DEEP INSPECTION SERVICES
OPENING DATE: 5/29/25
OPENING TIME: 11:00 a.m.
RFP NUMBER: 2532-25

This Addendum No. 1 is being issued to answer the following questions:

ADDITIONS & ALTERATION TO:
Old Greenwich Elementary School
285 SOUND BEACH AVENUE
OLD GREENWICH, CONNECTICUT 06870

Drawn By: **SOIL EROSION AND SEDIMENT CONTROL DETAILS**
 Project Title: **ISSUED FOR BID**
 Project Phase: **STATE PROJECT #037-0115 EARRUCV**

Date: 11/22/2024
 Sheet No: **CE501**
 Project No: **03/19/2025**
 Project Number: **23-382**

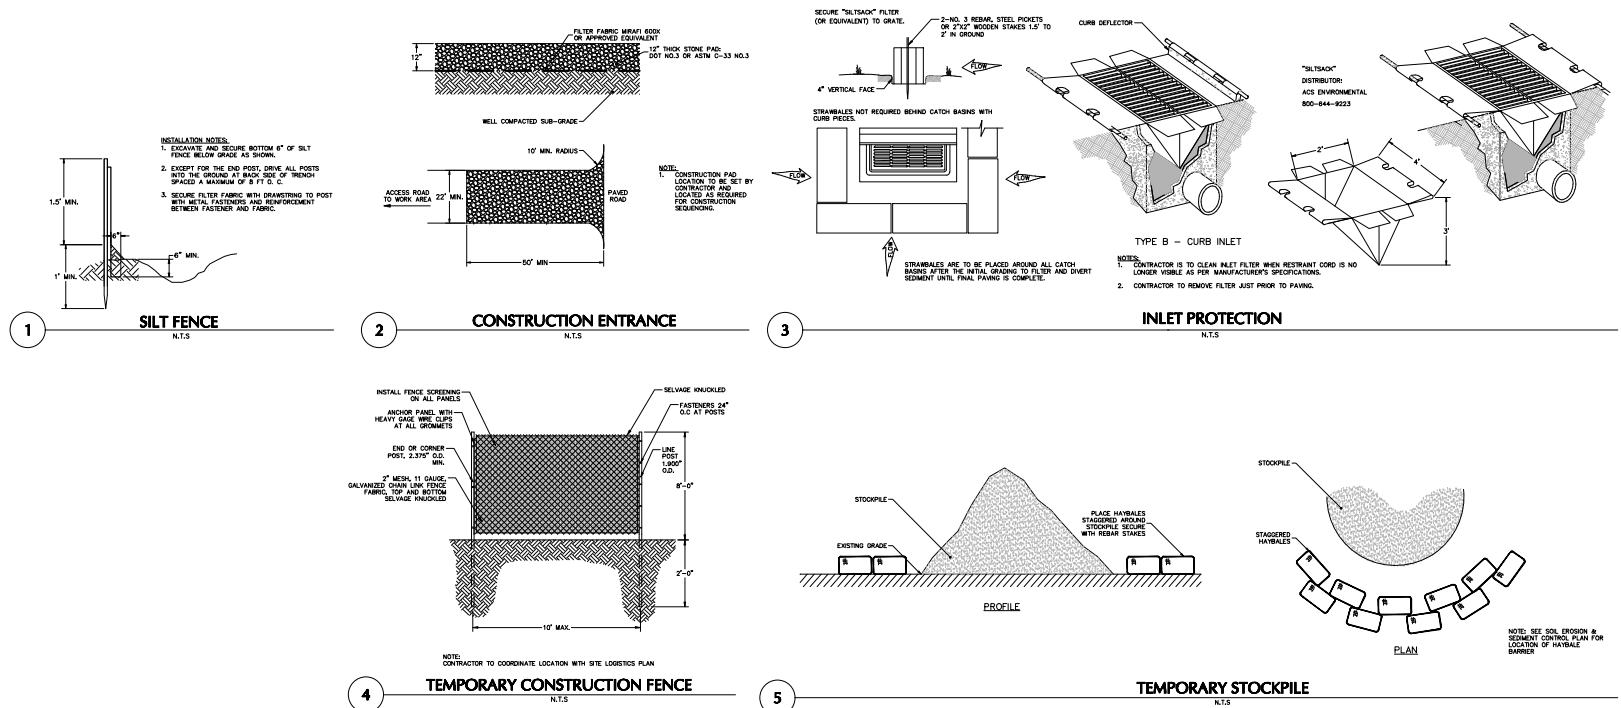
1. Can you please provide Erosion & Sedimentation Control Plan drawings and details for this project?

Answer : **Attached are sheets CE101 and CE501.**
